Info Only: EPC engineering comments are in blue text.

Final Drainage Report

Townhomes at Western

PPR2415

Project: Inlet ID: Inlet A4

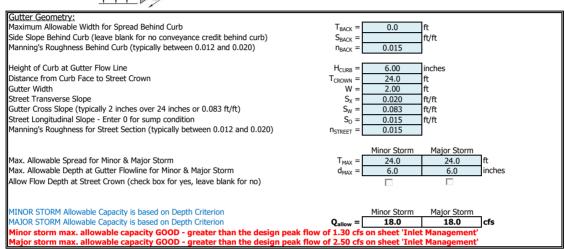
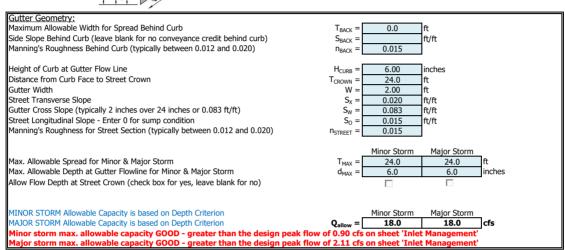
Why the capture percentage is above 100%. Please revise. This comment is applied to all applicable inlets.

Where does bypass flow go? Please revise to match the text discussion and the inlet tab management. This comment is applied to Inlet No. A3, A10,

STORM LINES 1 & 2

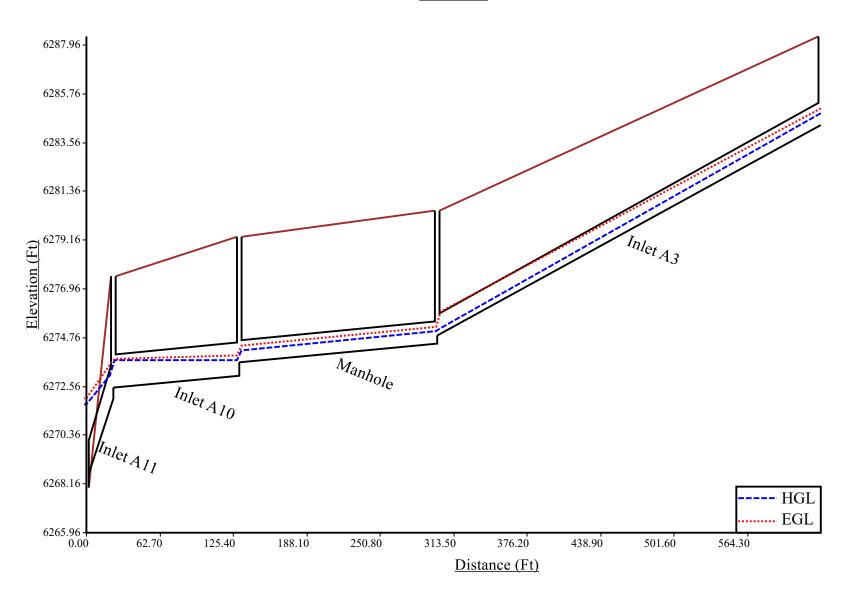
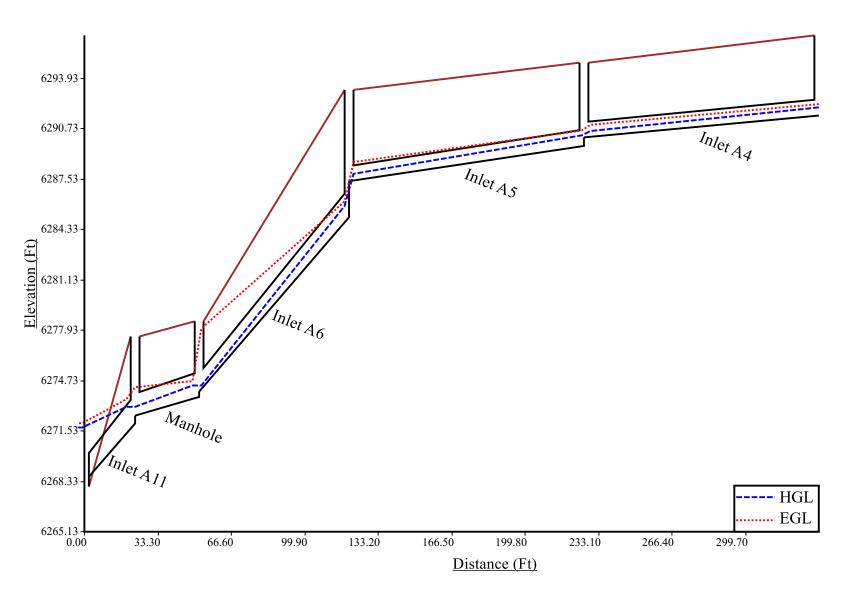
Velocity is above the maximum requirement. Please revise. If the condition cannot be met, please submit a deviation.

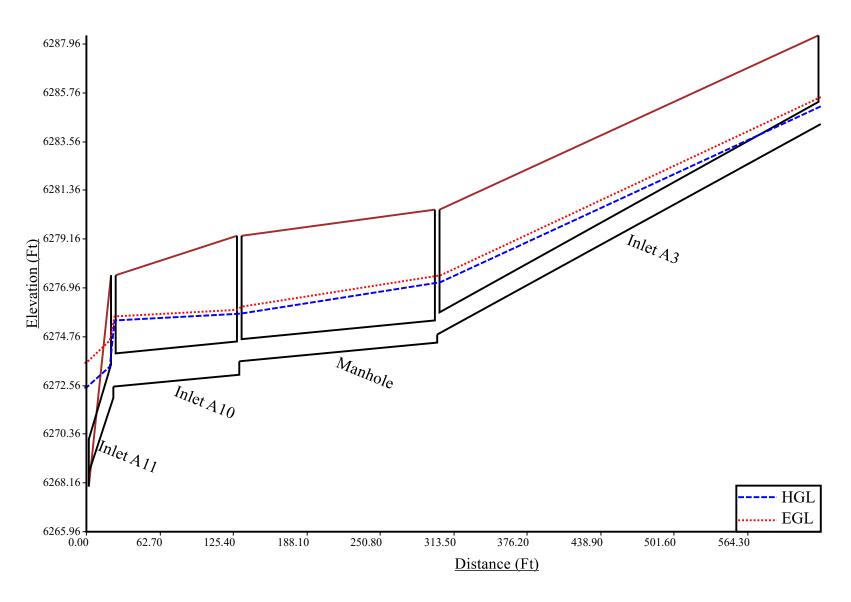
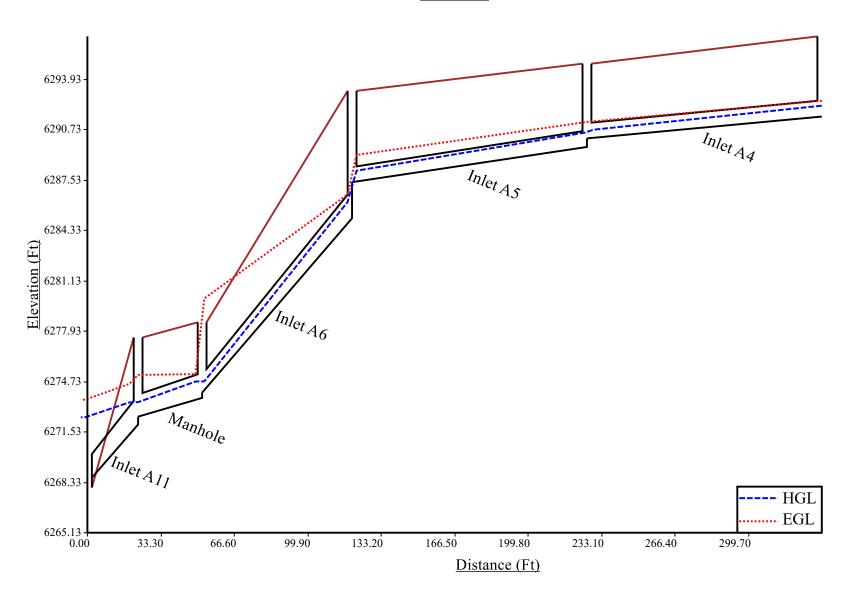
Please revise. If the condition cannot be met, please submit a deviation.
